UNITED STATES PATENT AND TRADEMARK OFFICE

APPLICATION NO.	FILING DATE	FIRST NAMED INVENTOR	ATTORNEY DOCKET NO.	CONFIRMATION NO.
10/539,045	03/06/2006	Johan Ulin	12090-000016/US	7386
30593	7590	04/28/2009	EXAMINER	
HARNESS, DICKEY & PIERCE, P.L.C. P.O. BOX 8910 RESTON, VA 20195			WHITE, DENNIS MICHAEL	
ART UNIT	PAPER NUMBER			
			1797	
MAIL DATE	DELIVERY MODE			
04/28/2009			PAPER

Office Action Summary	Application No. 10/539,045	Applicant(s) ULIN ET AL.
	Examiner DENNIS M. WHITE	Art Unit 1797

DETAILED ACTION

Fig. 8

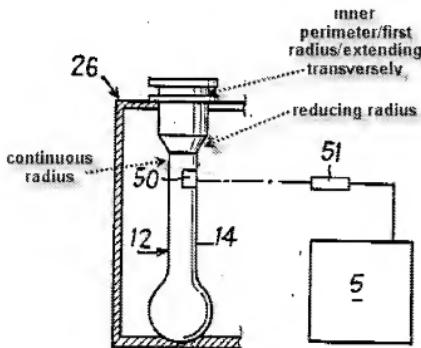
Regarding claims 20-21, Commarmot/Jennings the container has a rim that extends to the diaphragm, sealing the open end of the vessel wherein a reducing radius portion smoothly transforming into a portion of continuous radius defining a reaction chamber of the verse cavity. Commarmot further shows container 12 wherein the upper rim extends transversely (see Fig. 8 below).
